Plan Holders of: **11th Street East Tracy Overhead Bridge Replacement Project**
CIP 73063

Subject: Addendum No. 1

ADDENDUM NO. 1

Plan Holders of: **11th Street East Tracy Overhead Bridge Replacement Project**
CIP 73063

S-14

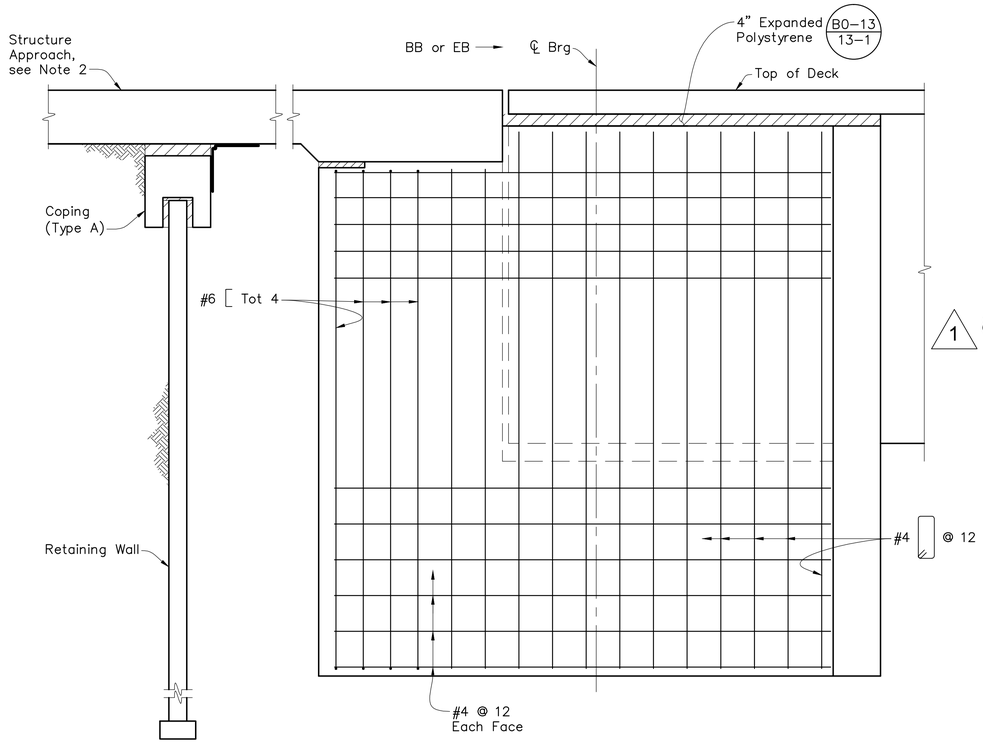
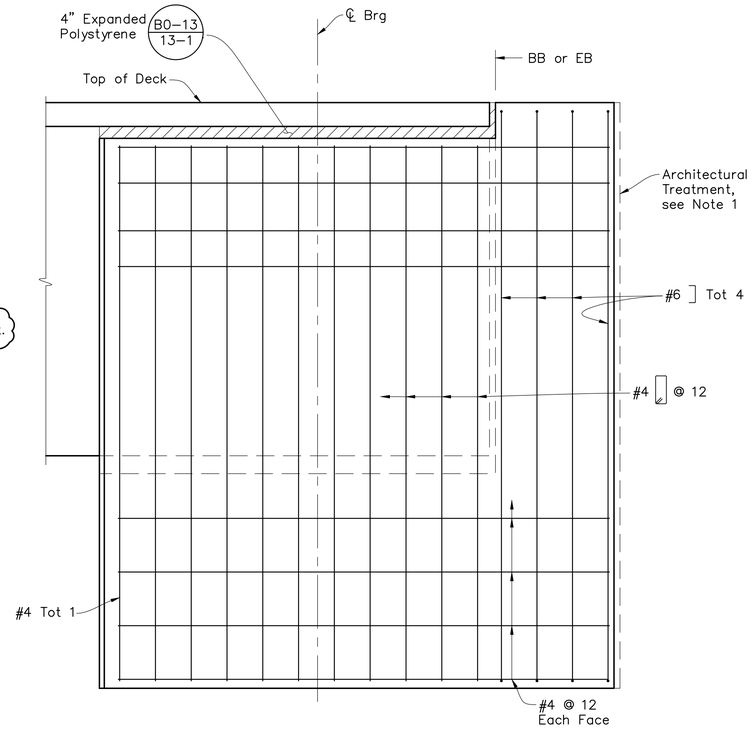
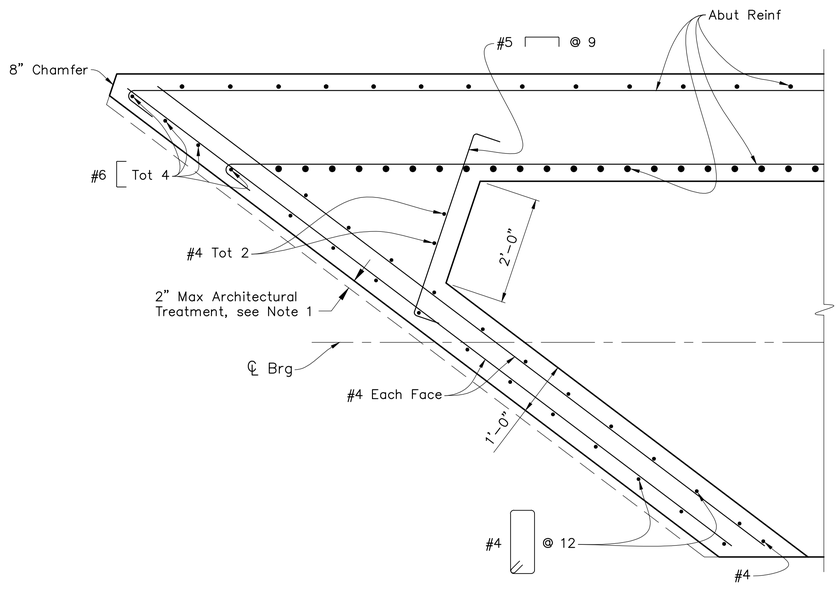
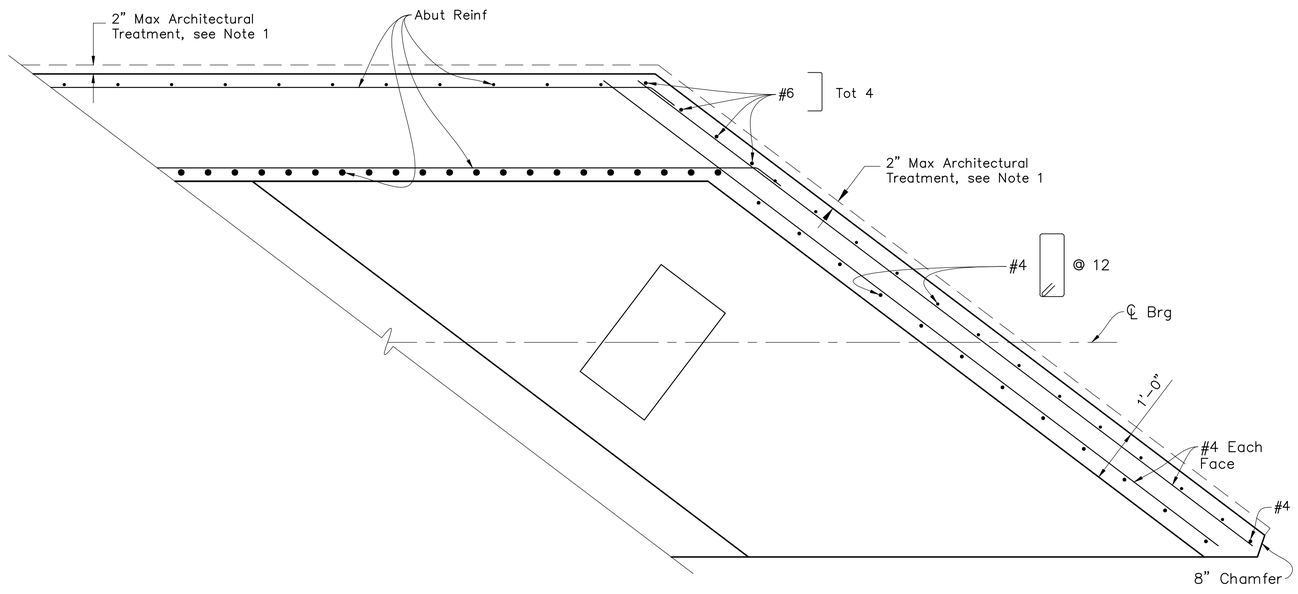
Item No. 9: **PROJECT PLANS –** Sheet 215 of 260, ABUTMENT 1 LAYOUT (Drawing S-7); Sheet 216 of 260, ABUTMENT 2 LAYOUT (Drawing S-8); Sheet 217 of 260, ABUTMENT LAYOUT DETAILS (Drawing S-9); and Sheet 222 of 260, ABUTMENT DETAILS NO 5 (Drawing S-14):

- Note 5 on Drawings S-7 & S-8 and Note 1 on Drawings S-9 and S-14 have been changed from referencing "Aesthetic Details No. 2" sheet, to correctly reference "Aesthetic Details No. 3" sheet

SECTION F-F (SEE NOTE 2)

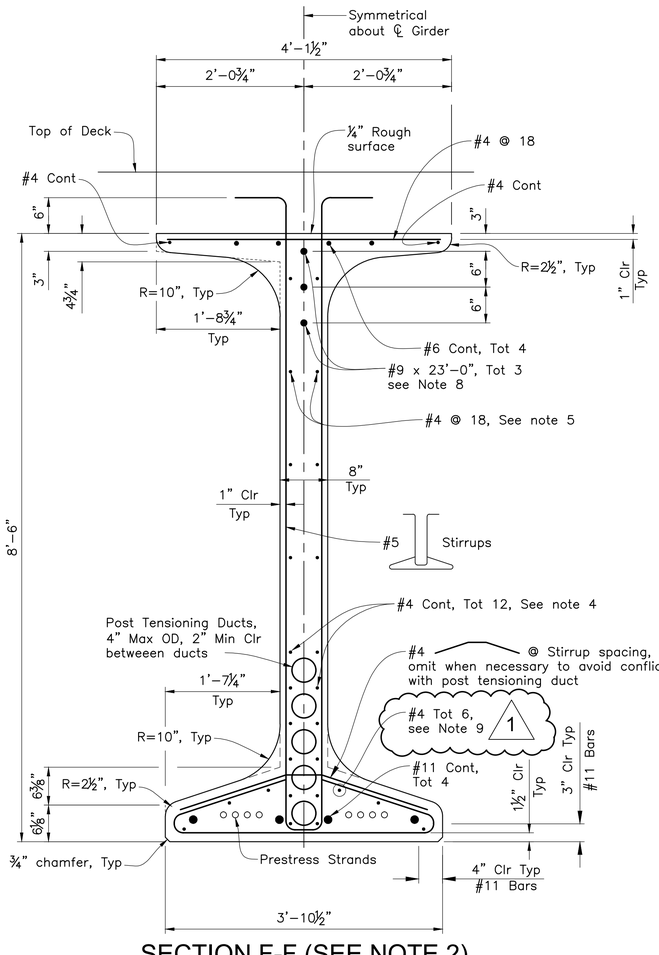
Item No. 11: **PROJECT PLANS -** Sheet 229 of 260, GIRDER DETAILS NO. 3 (Drawing S-21), and Sheet 230 of 260, GIRDER DETAILS NO. 4 (Drawing S-22):

- Note 9 has been added to Drawing S-21
- Added a reference to Note 9 for #4 bar reinforcement, total 6 callout on Section F-F on Drawing S-21.
- Added #4 bar reinforcement, total 6 to the bottom flange of Section K-K (girder splice section) on Drawing S-22.

CS-6

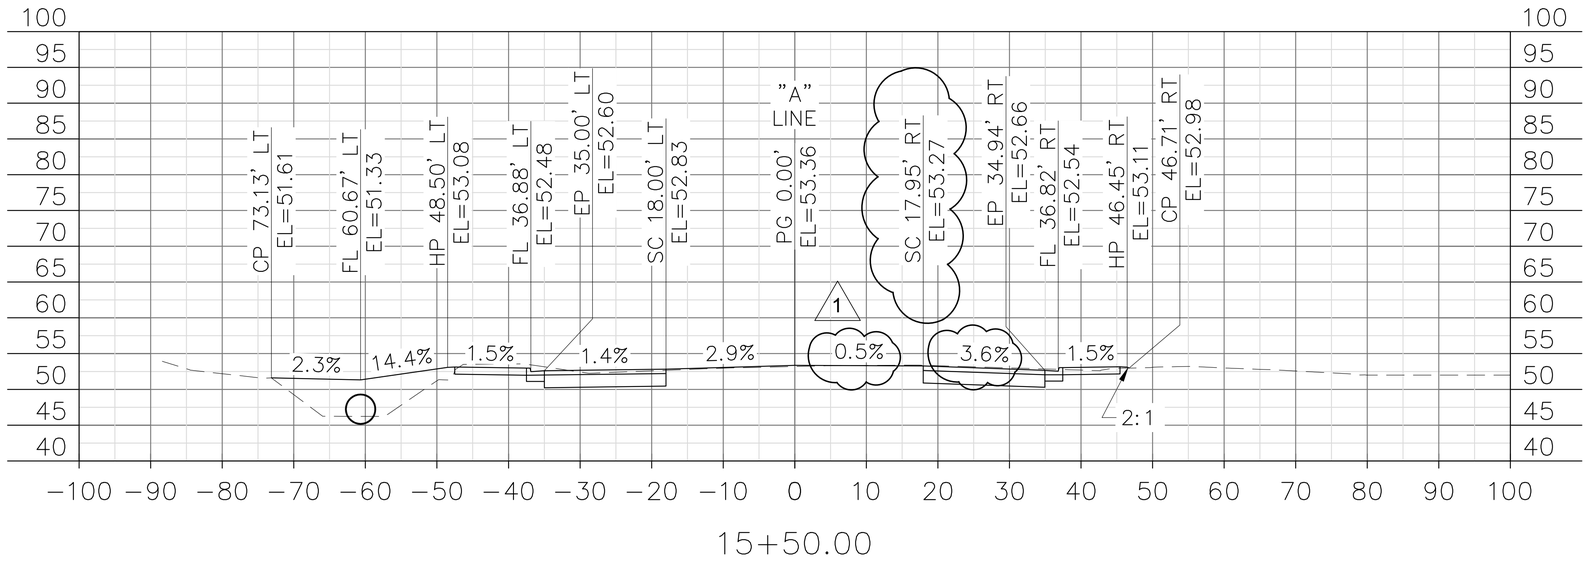
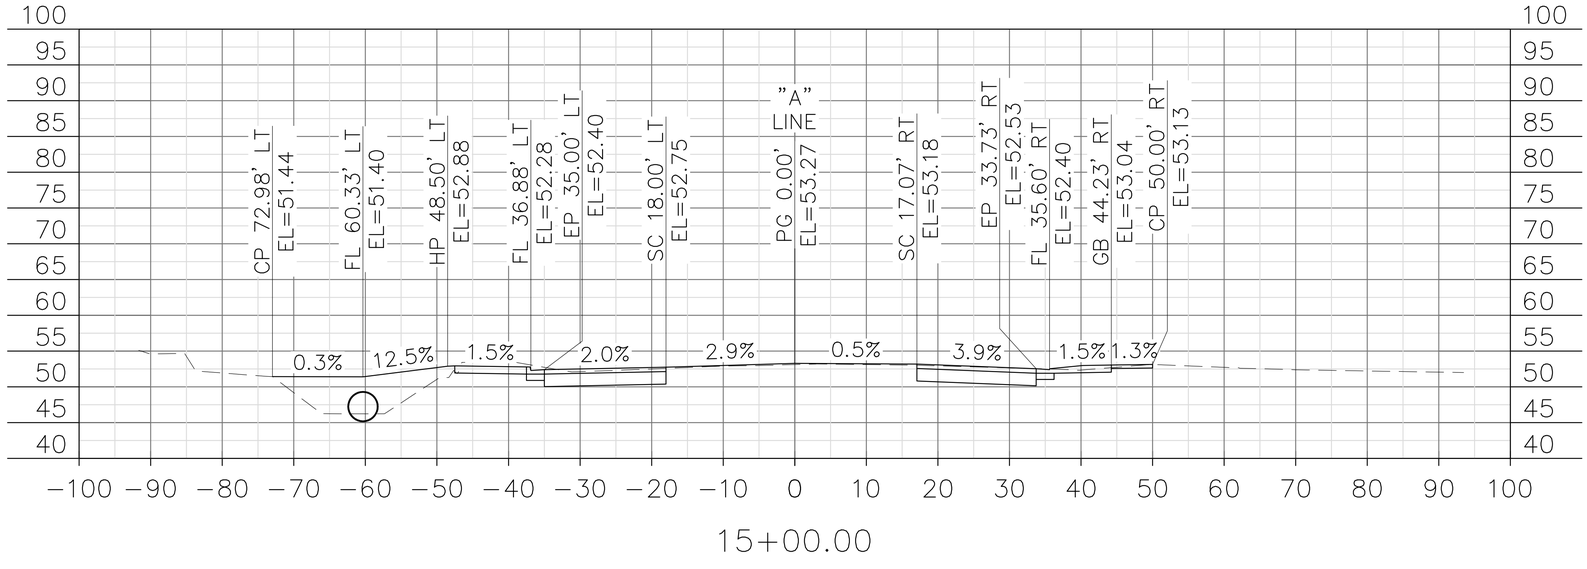
Item No. 15: INFORMATION HANDOUT, ITEM A – Construction Cross Sections, Sheet 6 of 68, 11th STREET CROSS SECTIONS (Drawing CS-6):

- Slope callout has been revised from "1.0%" to "0.5%"
- Slope callout has been revised from "5.1%" to "3.6%"
- Station elevation callout has been revised from "EL=53.54" to "EL=53.27"
